**PRELIMINARY DRAINAGE REPORT
FOR
CLOVERLEAF SUBDIVISION PRELIMINARY PLAN**

**May 28, 2020
Project No. 25158.01**

**Prepared By:
JR Engineering, LLC
5475 Tech Center Drive, Suite 235
Colorado Springs, CO 80919
719-593-2593**

Detention Basin Outlet Structure Design

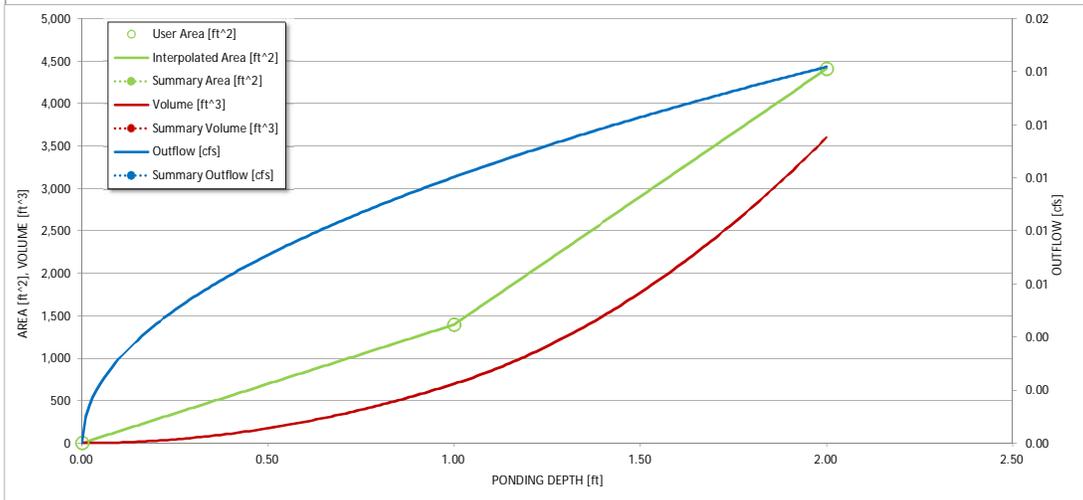
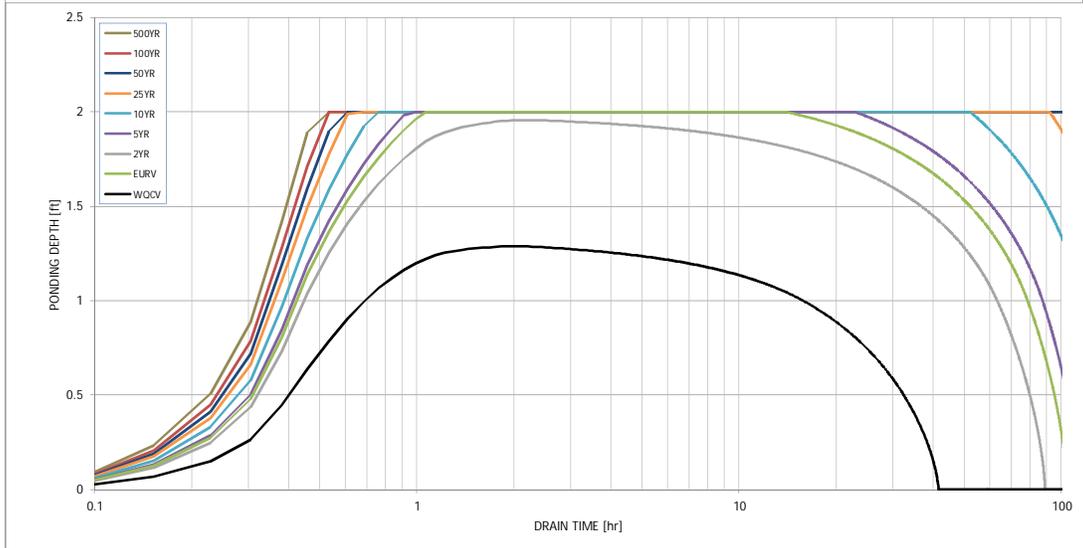
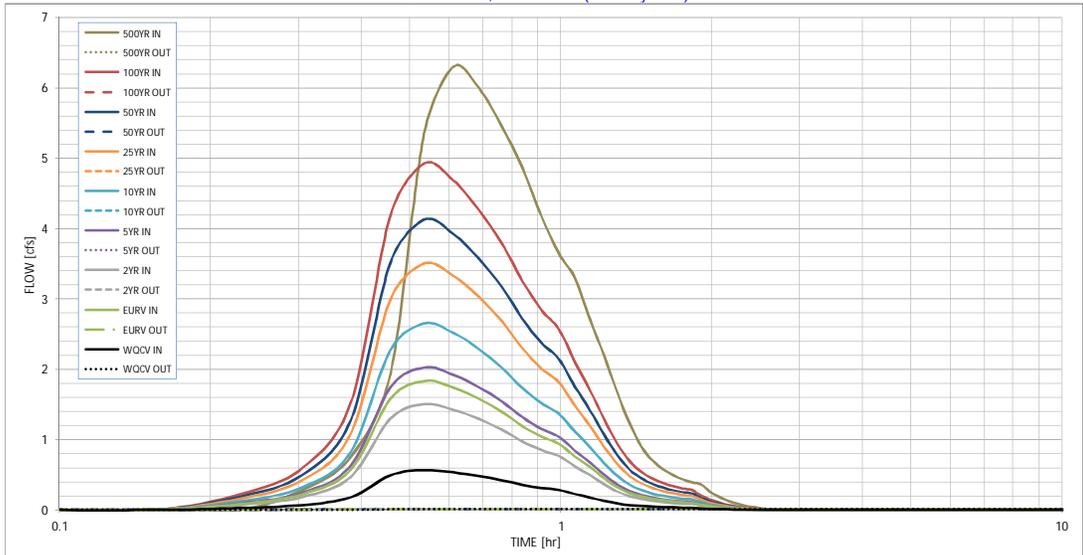
Add a footnote that this is WQ Only.

EXISTING CONDITIONS CUHP/SWMM BASINS & ROUTING MAP

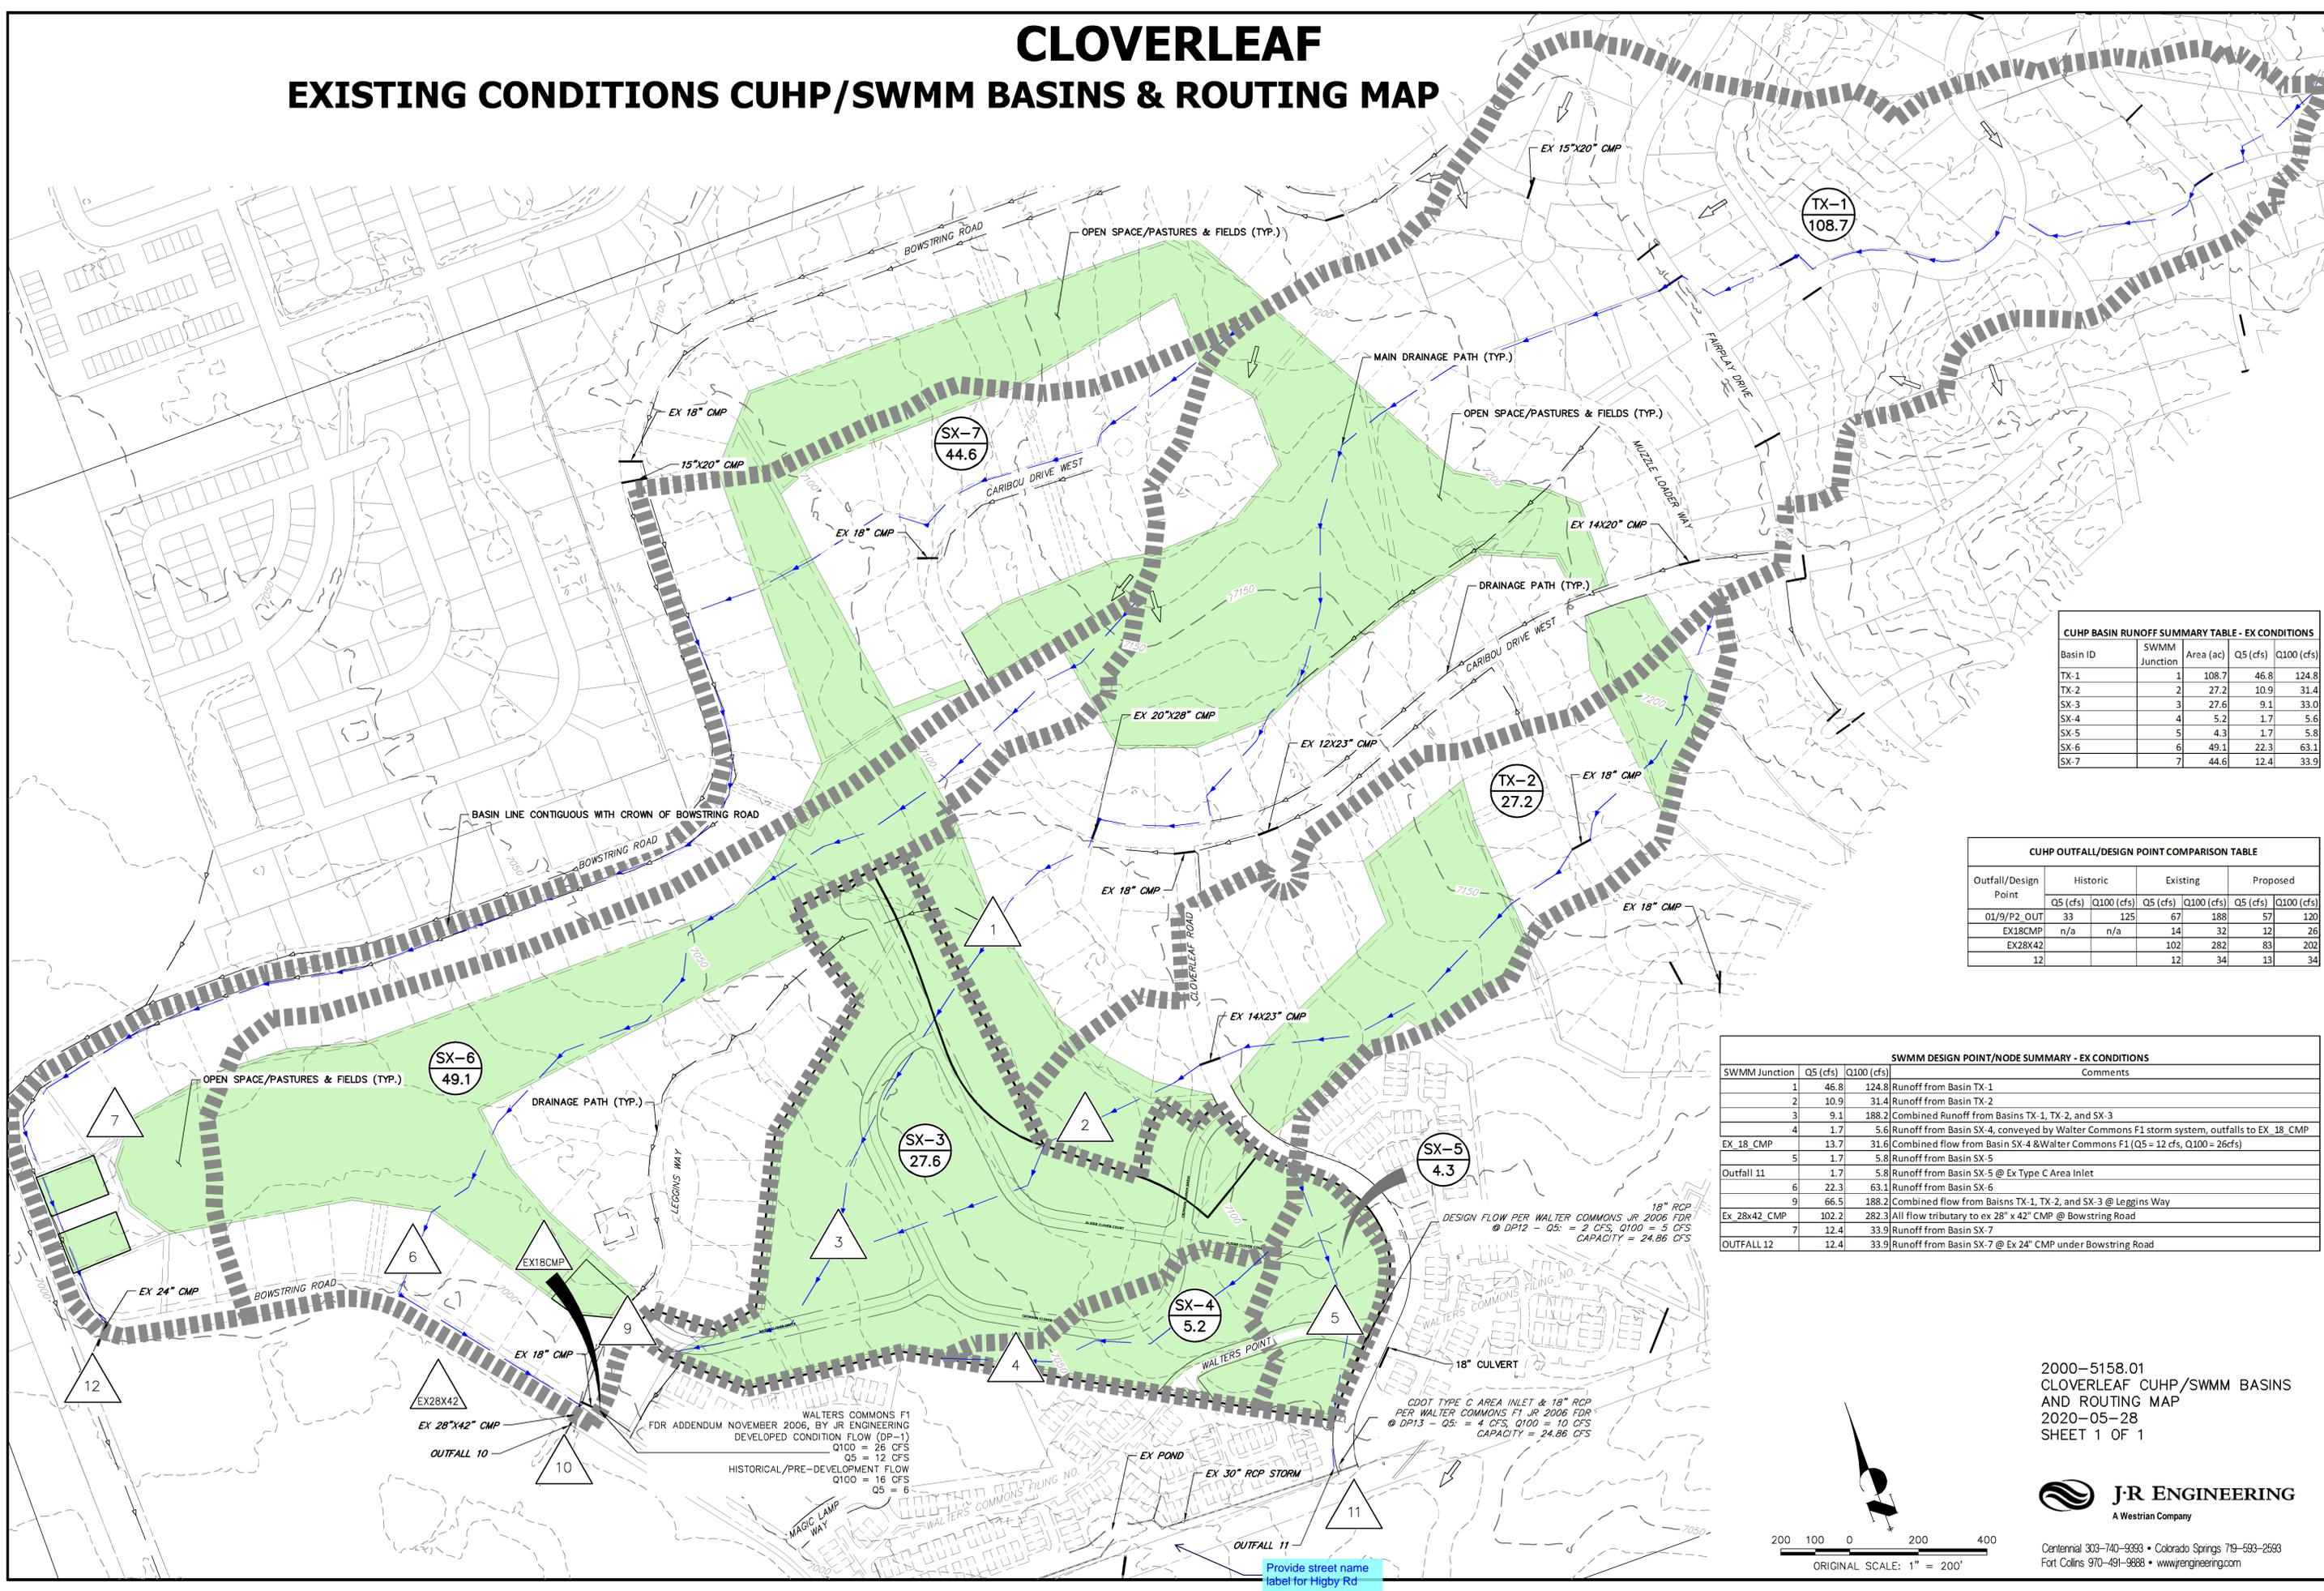
Provide street name
 label for Higby Rd

CLOVERLEAF SUBDIVISION PROPOSED DRAINAGE MAP

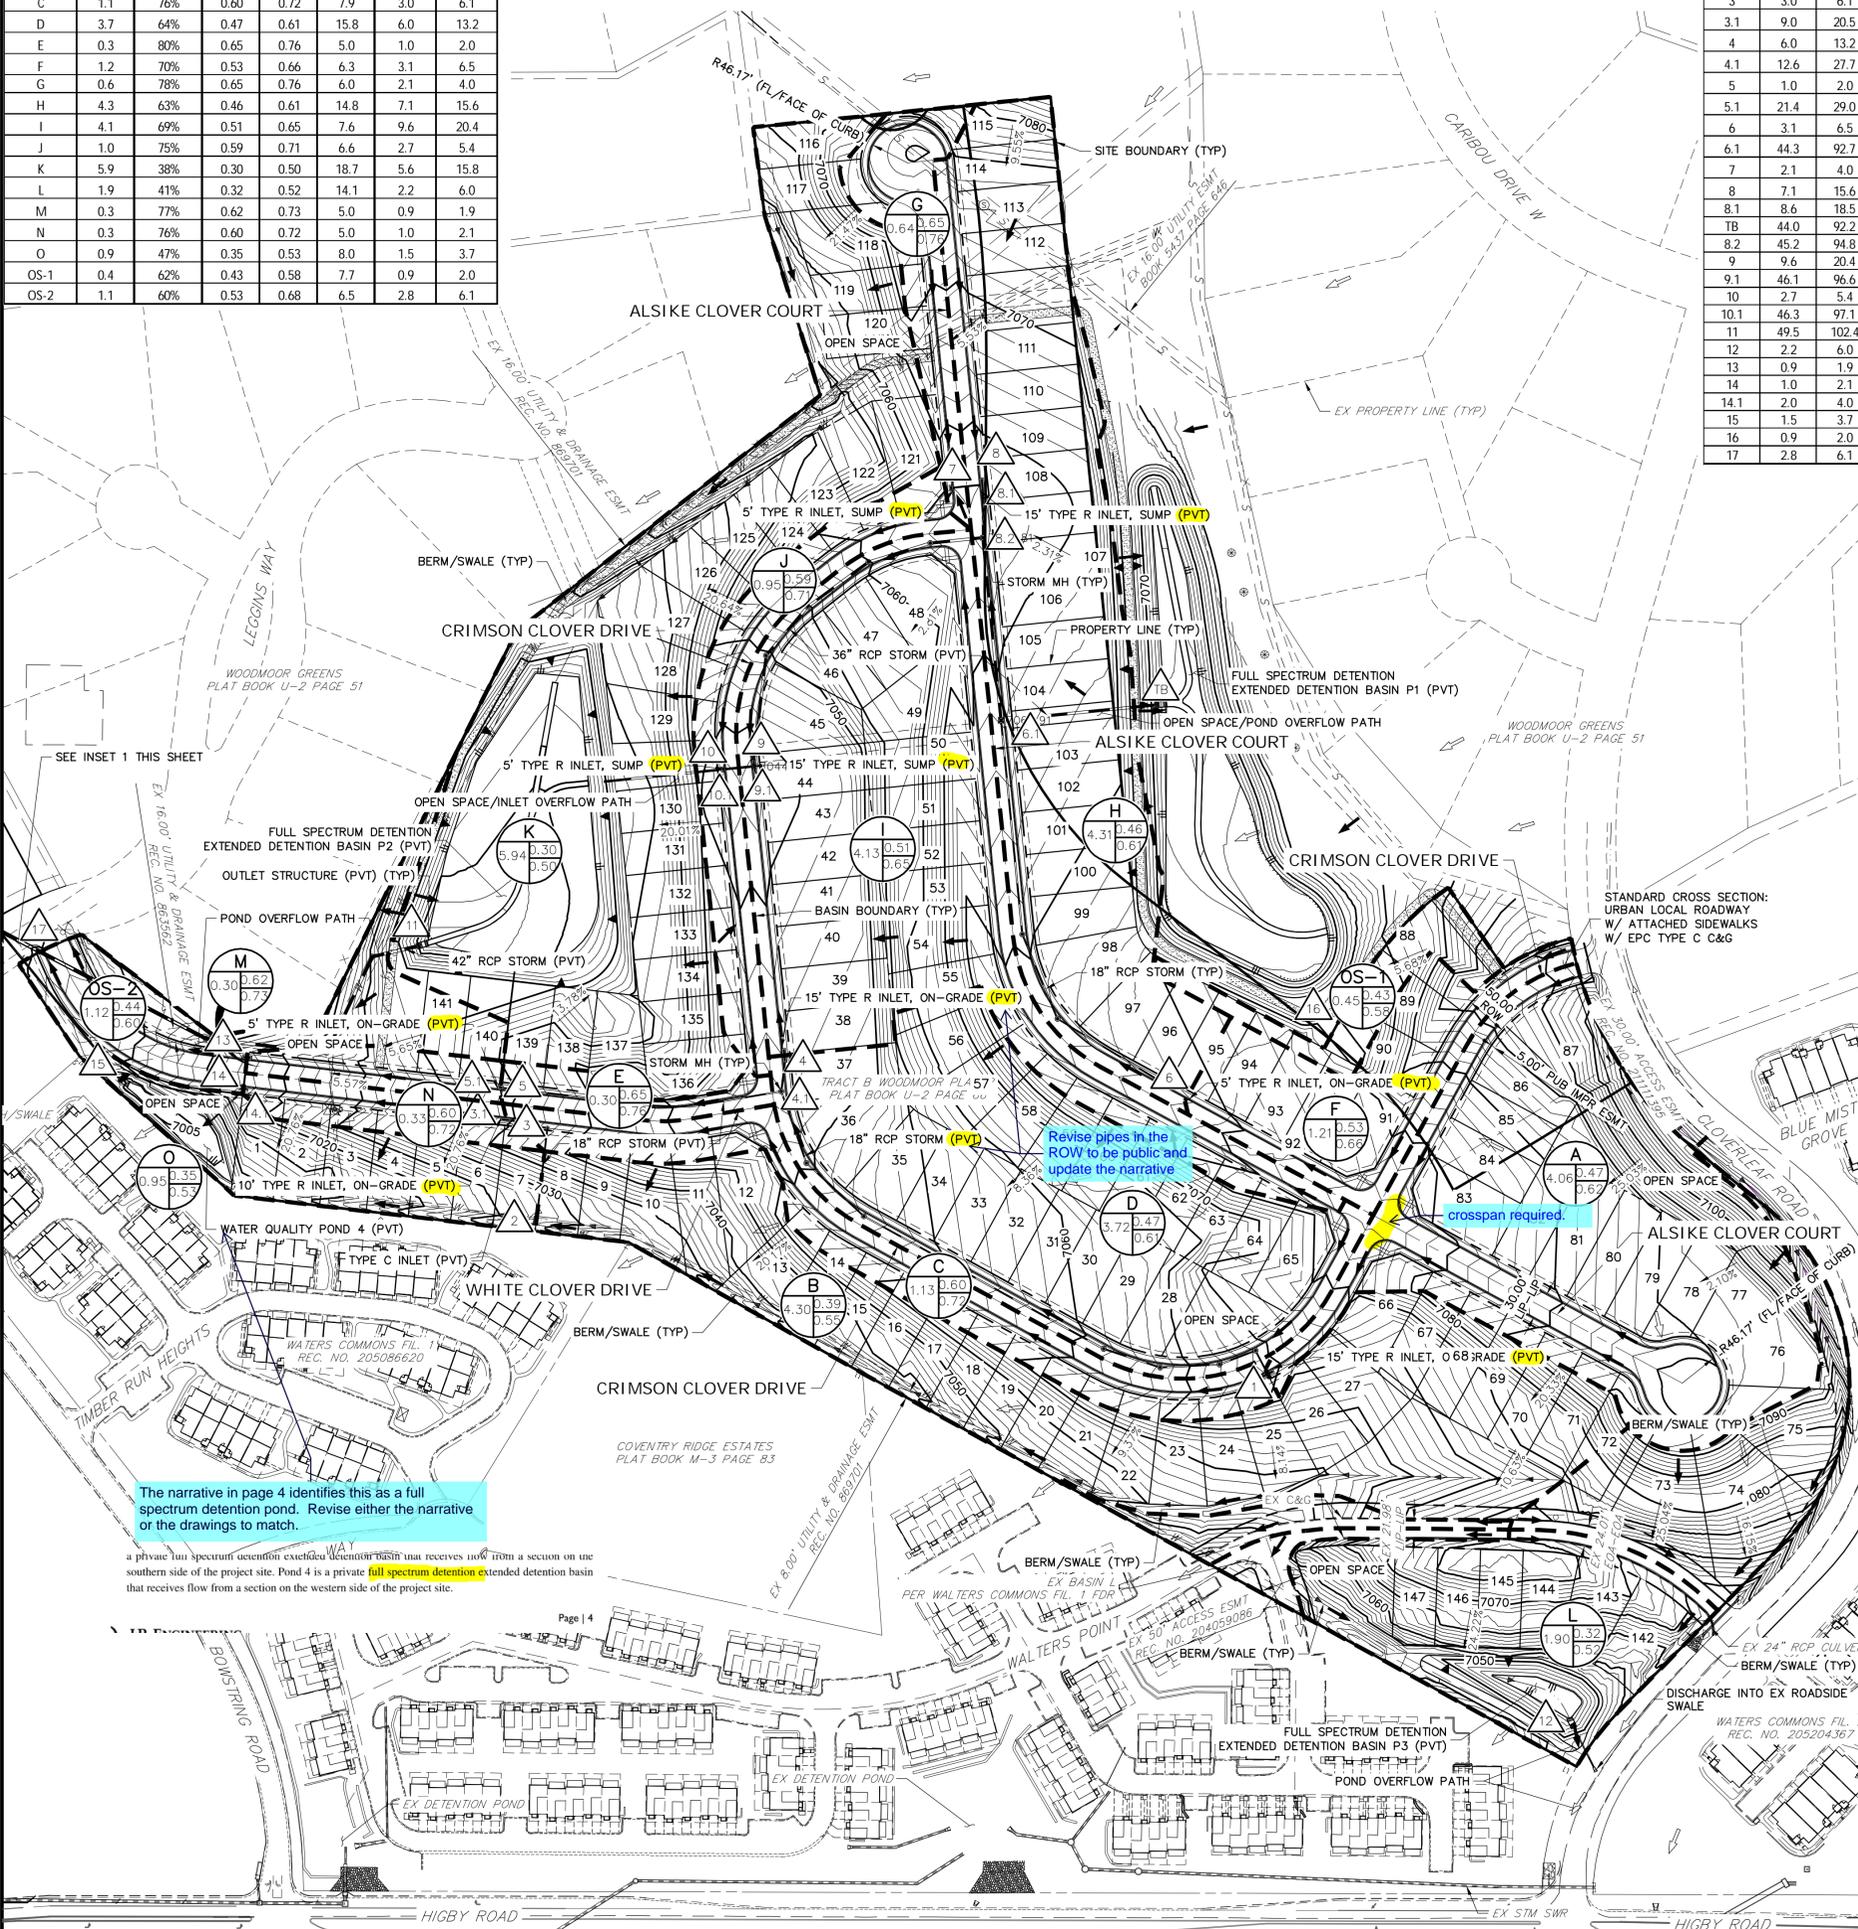
The narrative in page 4 identifies this as a full spectrum detention pond. Revise either the narrative or the drawings to match.

SAND FILTER - PLAN VIEW
SCALE: N.T.S.

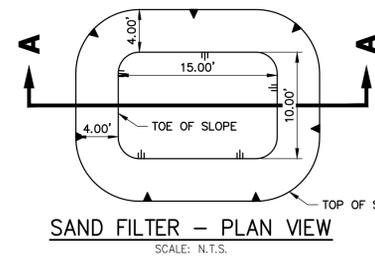
Update the WQ/Detention pond section (starts at pg 14) to include a narrative regarding the SF basins.
